1 SEATING LAYOUT

PROJECT TITLE:
UNIVERSITY OF WATERLOO

PRODUCT LINE:
Seminar
Loose Seating

DRAWING No.:
D787830_00_01_L01_F
03-16-2026 10:59 Lesley Smithers D787830_00_01_L01_F.dwg

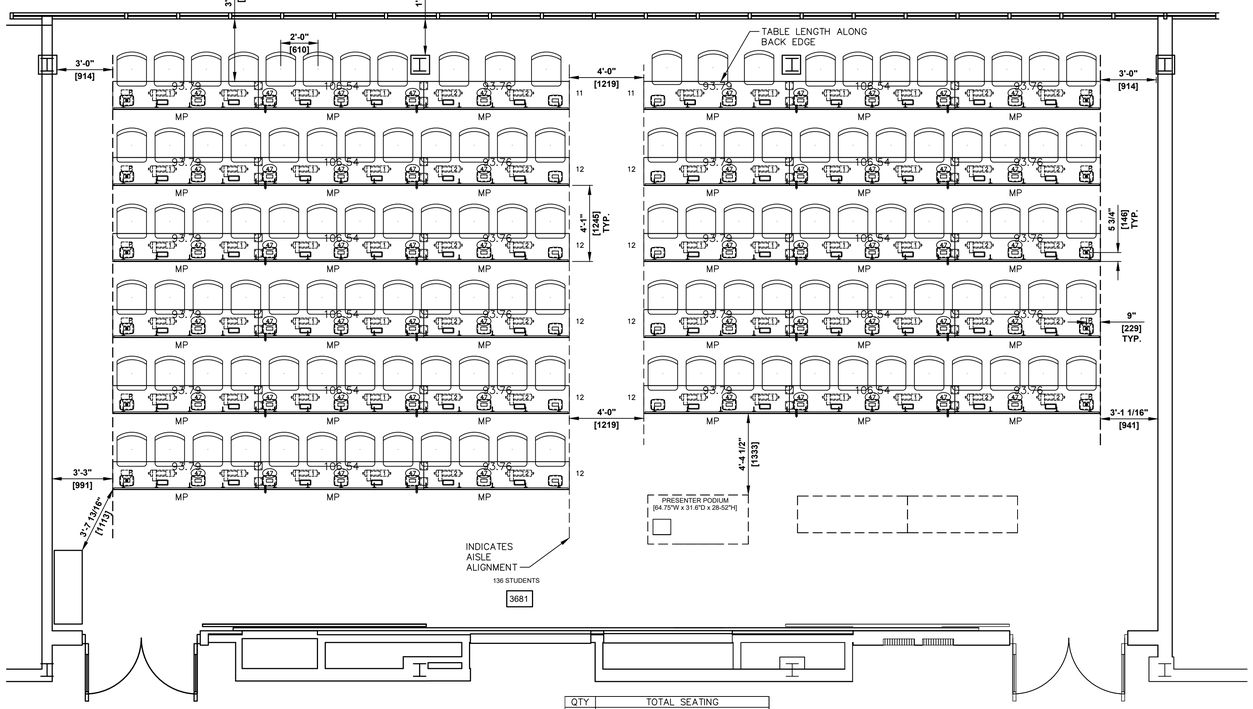
* VERIFY HANDICAP REQUIREMENTS AND ACCESSIBILITY *
* DATA NOT INCLUDED *

1-1 KI TYPICALLY PLANS WHEELCHAIR SPACES PER **IBC AND ICC A117.1** HOWEVER THEY HAVE NOT BEEN PLANNED ON THIS LAYOUT. PLEASE VERIFY ALL ACCESSIBILITY REQUIREMENTS PER LOCAL CODE AND COMMUNICATE ALL WHEELCHAIR SPACE LOCATIONS TO KI. ADDING WHEELCHAIR SPACES MAY REDUCE OVERALL SEATING QUANTITIES.

1-2 THE QUANTITY OF WHEELCHAIR SPACES IN THIS ROOM DOES NOT COMPLY WITH **IBC 1108.2.2.1** WHICH INDICATES THAT SEATING CAPACITIES OF 101 TO 300, REQUIRE 5 WHEELCHAIR SPACES (& CORRESPONDING COMPANION SEATS).
